CONVAIR

COMMERCIAL CHANGE PROPOSAL

SPEC NO. ZD- 30-013

CUSTOMER Swissair Transport Co., Ltd.

Page 7a
Report No. ZD-30-013
Model 30

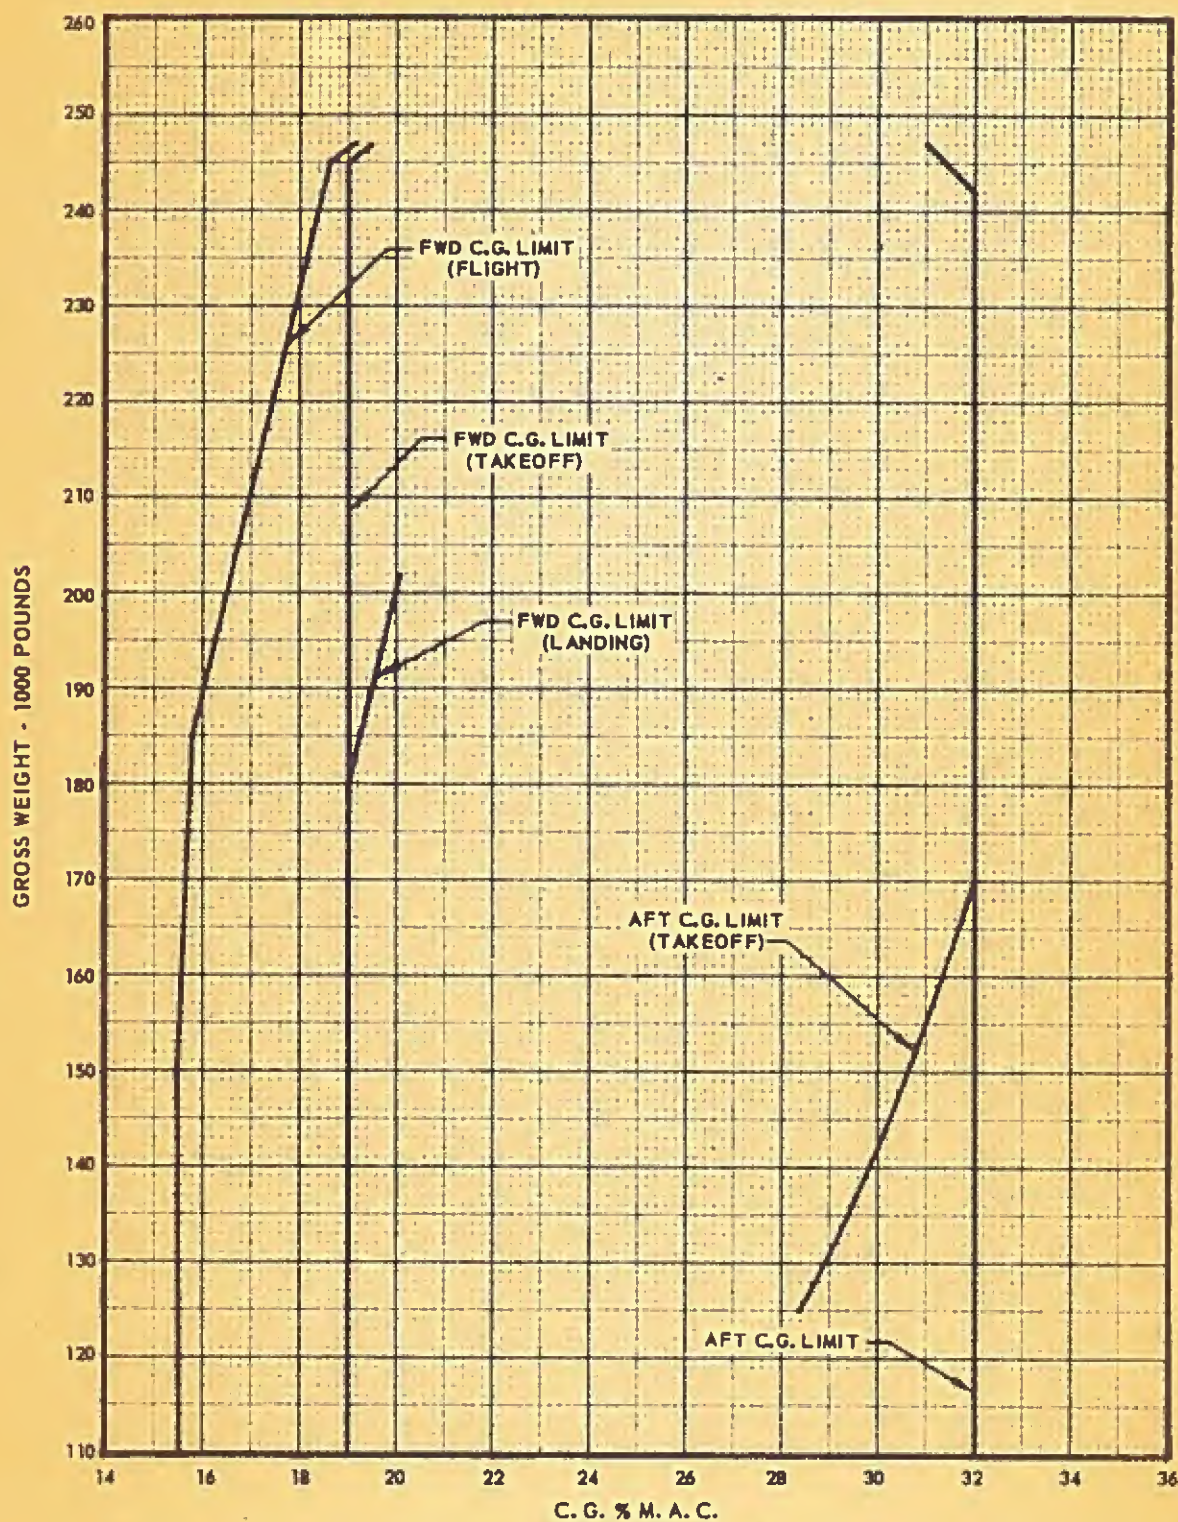
Revise the above illustration to show affects of this change.

Enclosure: (A) One copy Page 7a - C.G.Limits Illustration (Revised)

Enclosure: (A) One copy Page 74a - PILOT'S AND COPILOT'S INSTRUMENT
PANELS (Revised)

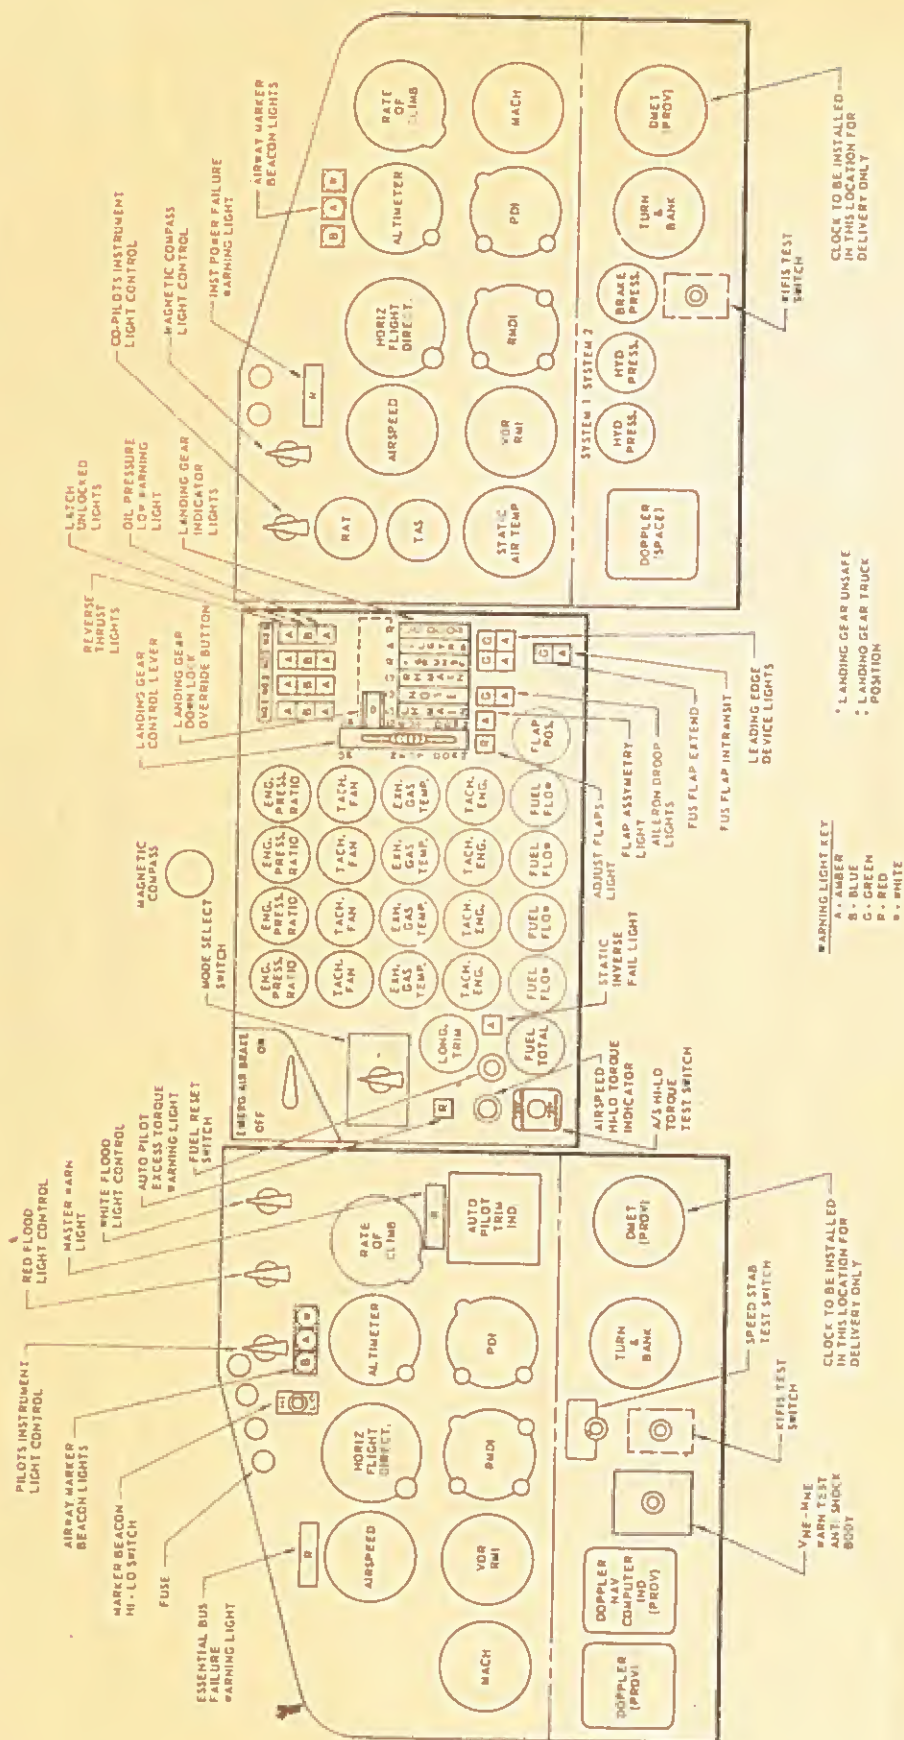
Replace the above illustration in the specification with Enclo-
sure (A) which shows the subject switch.

Enclosure: (A) One copy of Page 50a - PITOT STATIC SYSTEM (Revised)

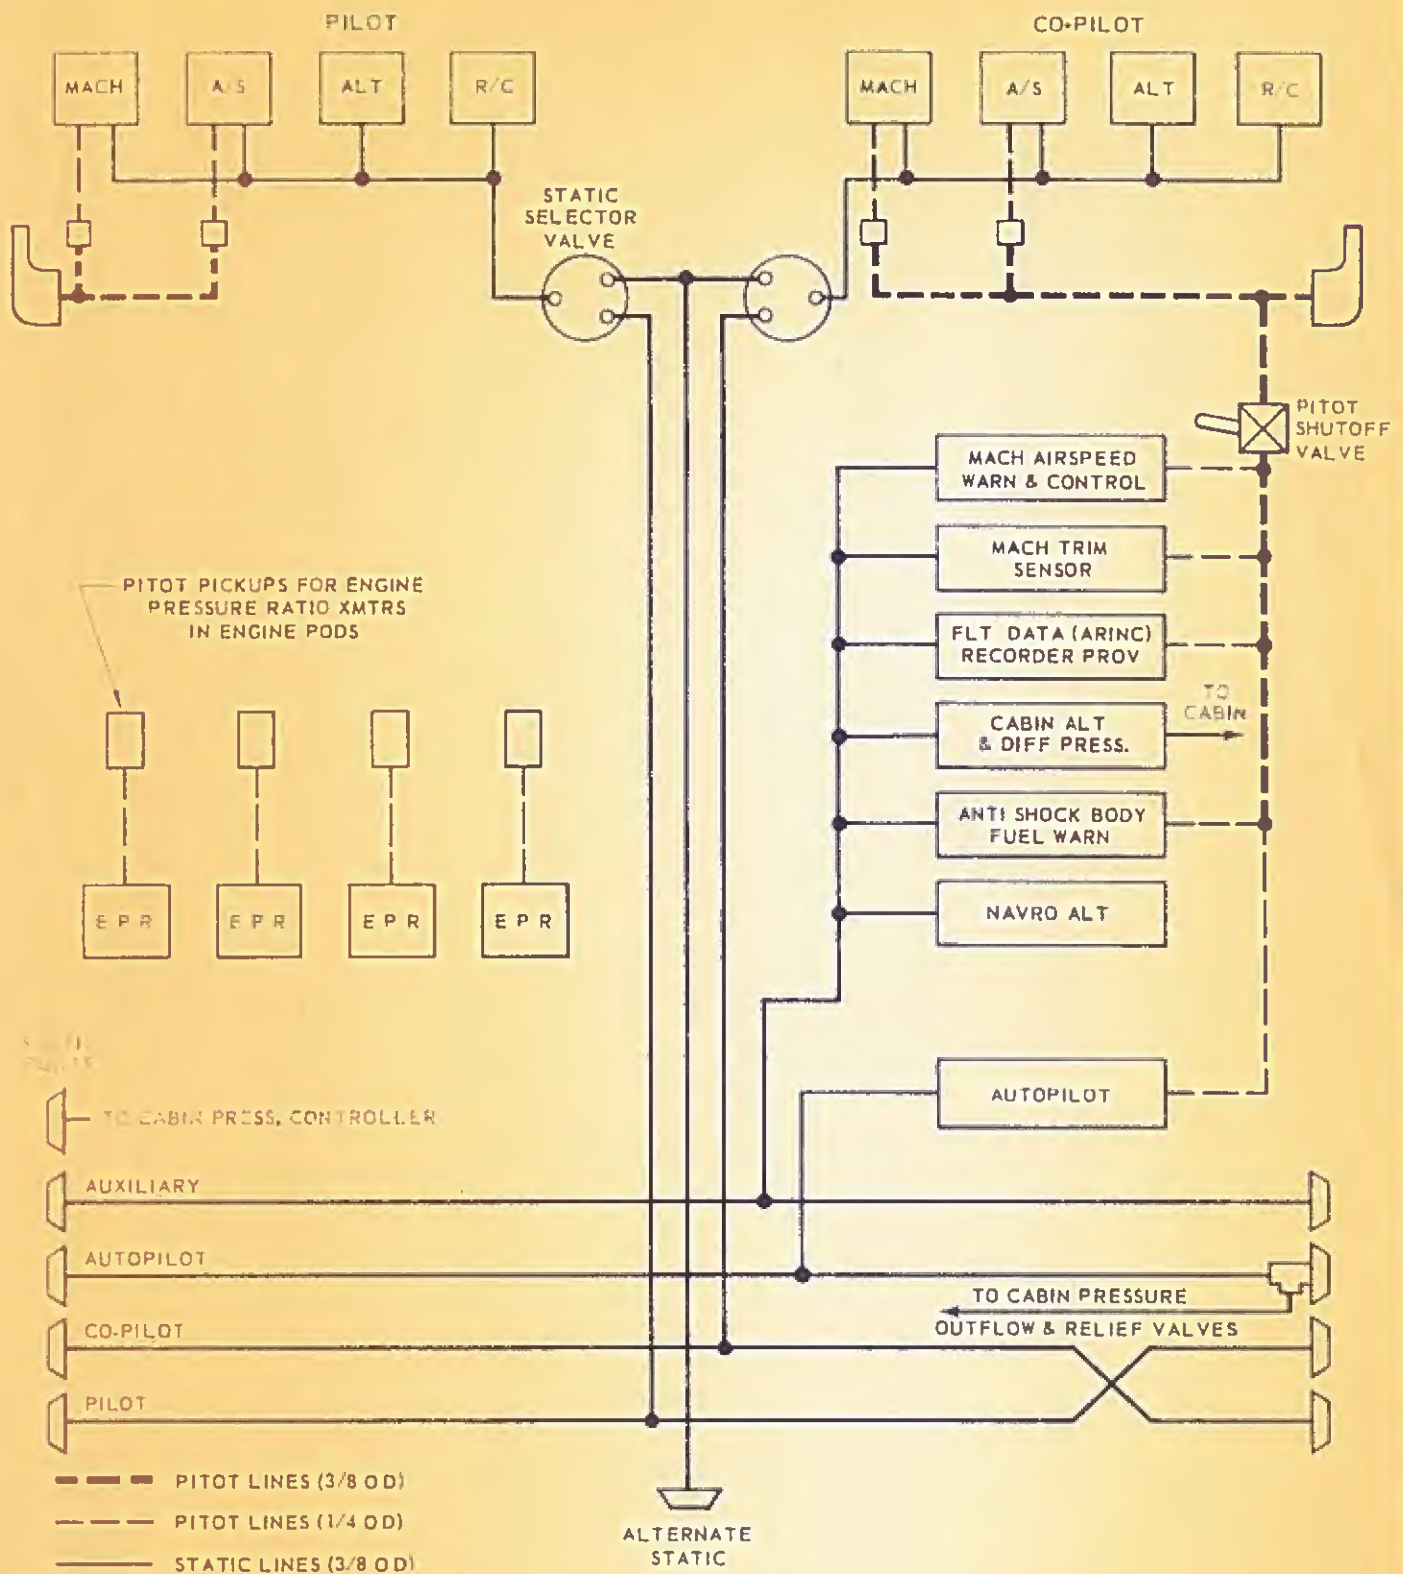
Replace above illustration in specification with Enclosure (A) which is revised to show current changes.

Enclosure: (A) One copy of Page 111a - ESTIMATED CABIN PRESSURE
SCHEDULE (Revised)

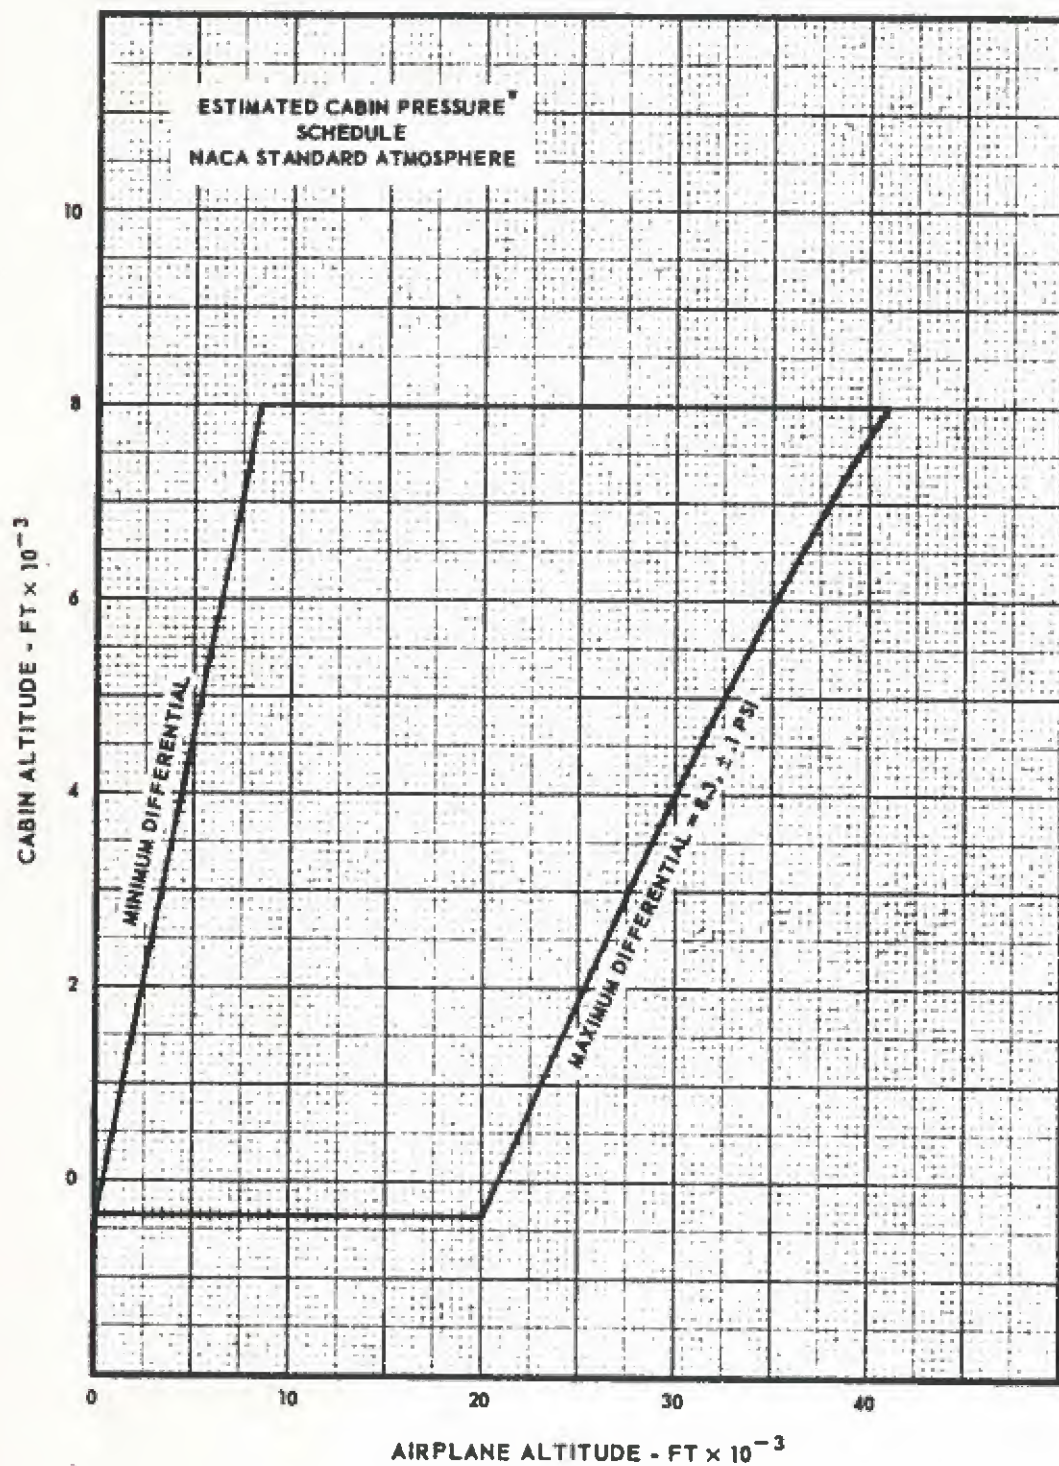
The above illustration shall be revised to show effect of this change.

Enclosure: (A) One copy Page 48d - FIRE CONTROL PANEL (Revised)

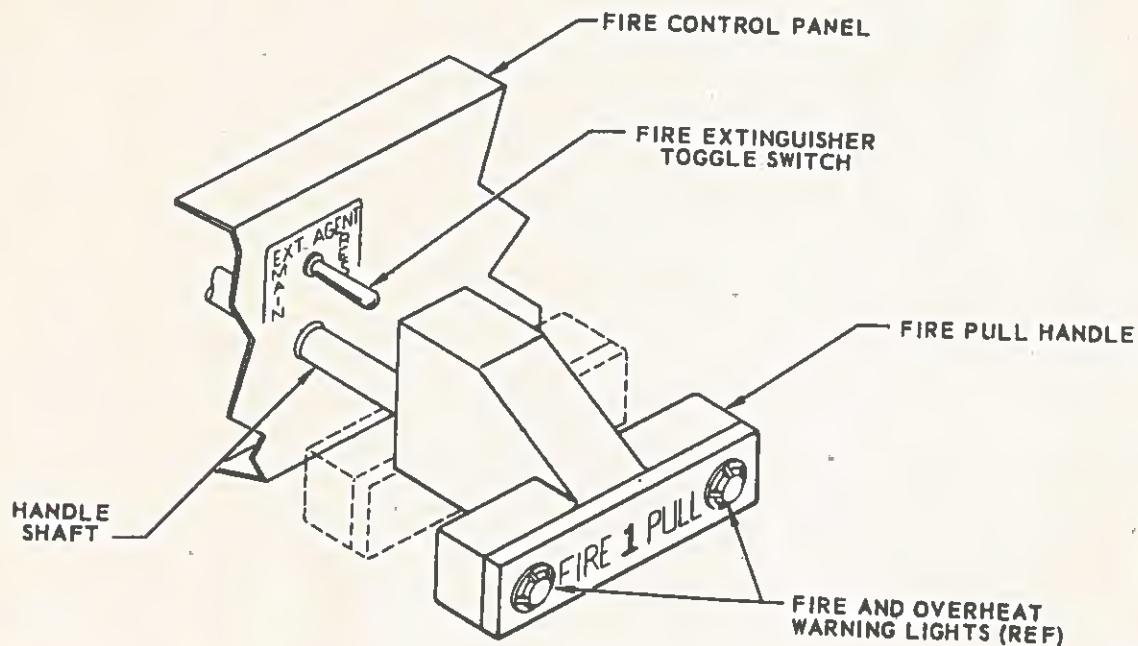
Reason for Change: 1. To provide latest current Fire Control Panel illustration which includes wheel well indicator lights.

Replace the above illustration in the specification with Enclosure (A).

Enclosure: (B) One copy Page 71a - WARNING HORN DIAGRAM (Revised)

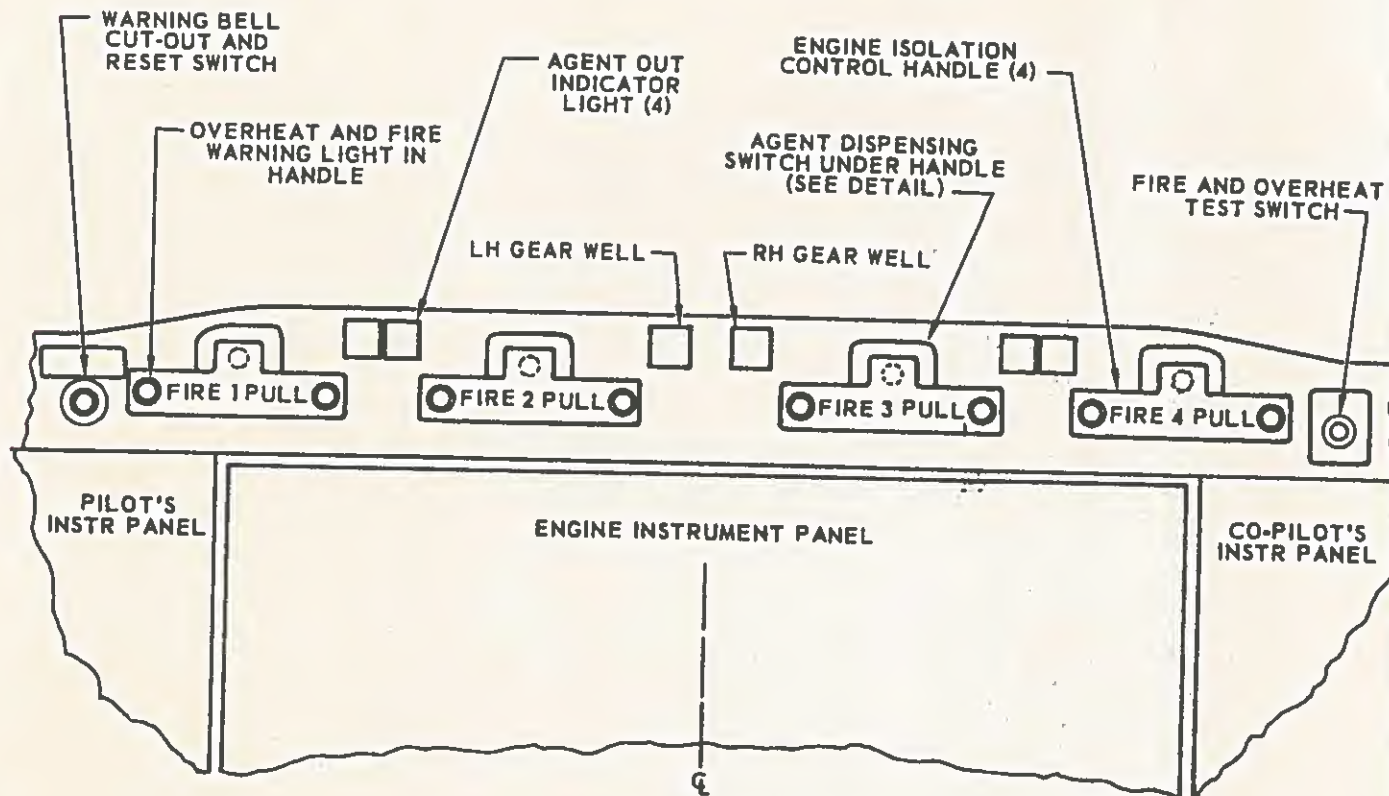
2. To provide Warning Horn illustration which includes all warning circuits, to make consistent with the actual installation.

Replace the above illustration in the specification with Enclosure (B).

Enclosure: (A) One copy Page 99a - FIRE EXTINGUISHING SYSTEMS
(Revised)

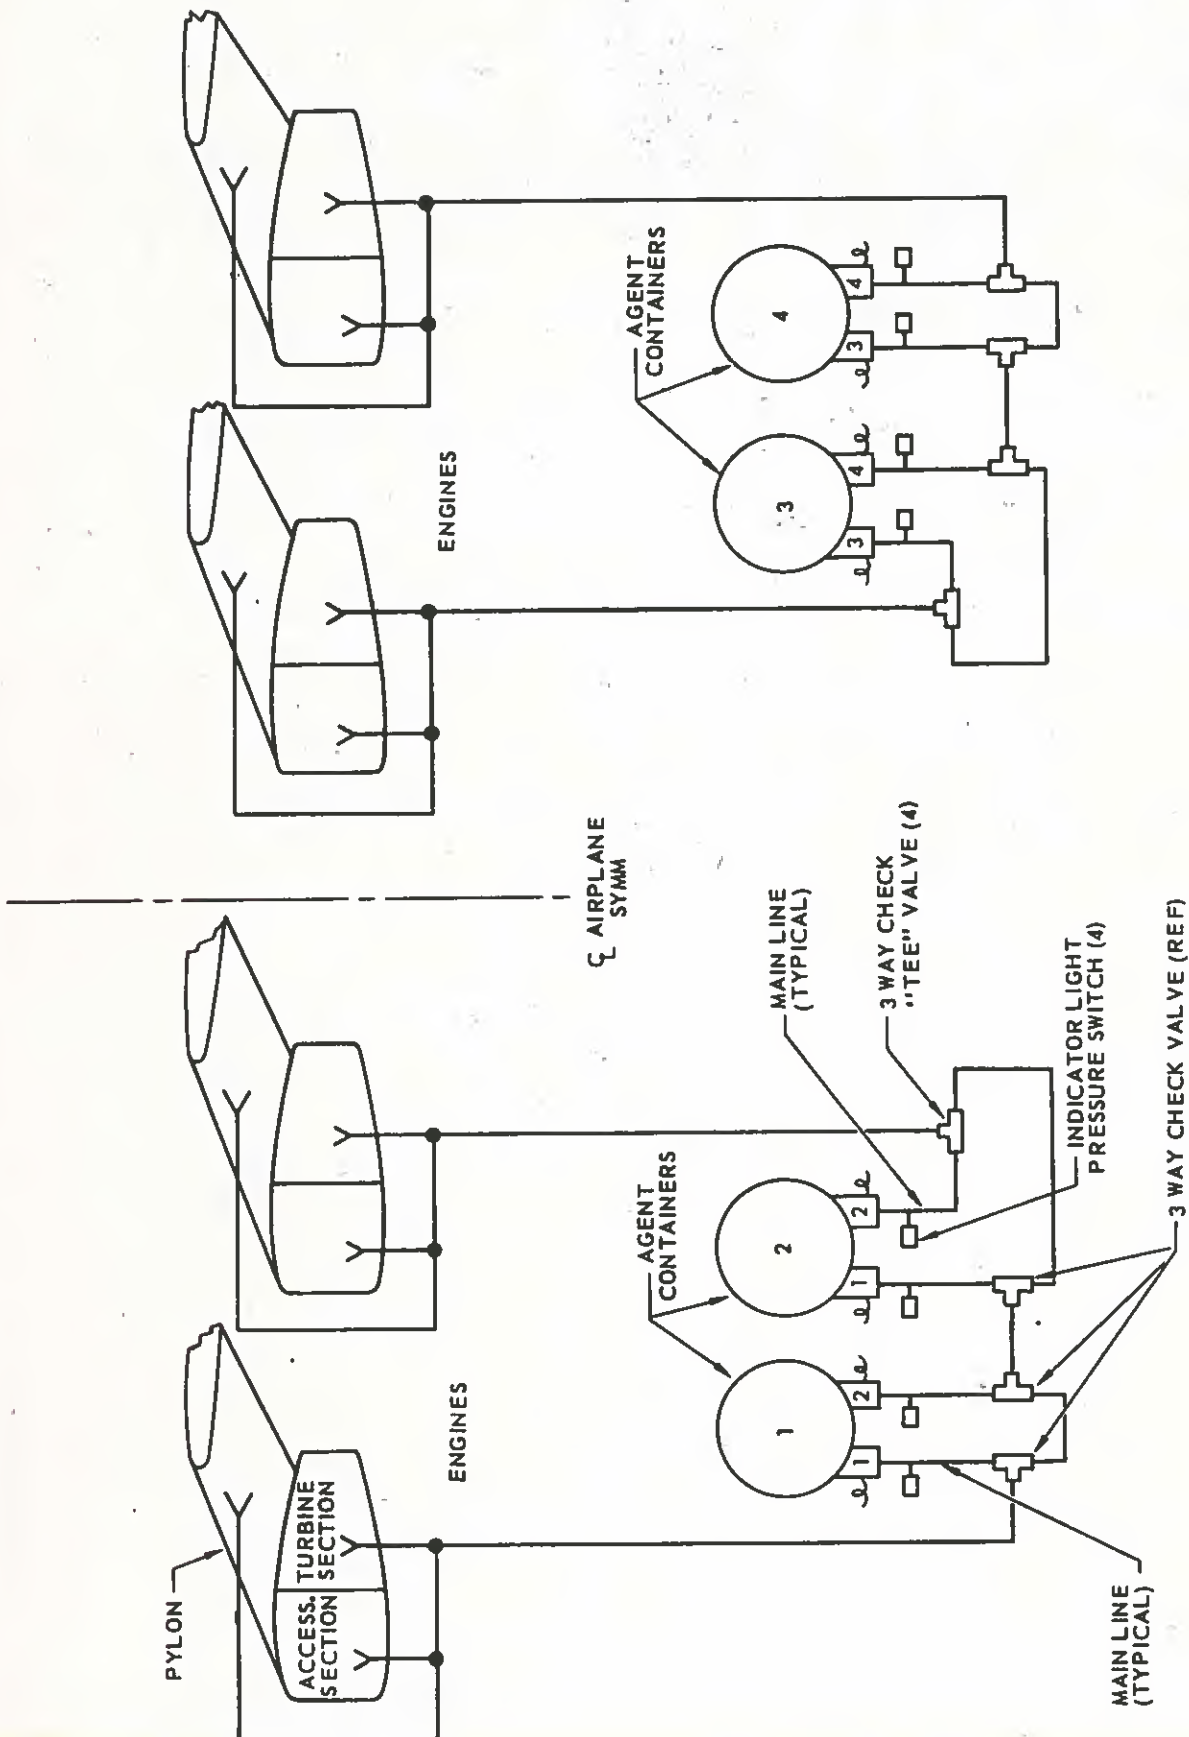
Reason for Change: To standardize subject illustration for all Model 30 aircraft, to avoid misinterpretation of letter and arrow coding of three-way check valves.

Replace the above illustration in the specification with Enclosure (A), which is proposed as the standard illustration for Model 30 Fire Extinguishing Systems.
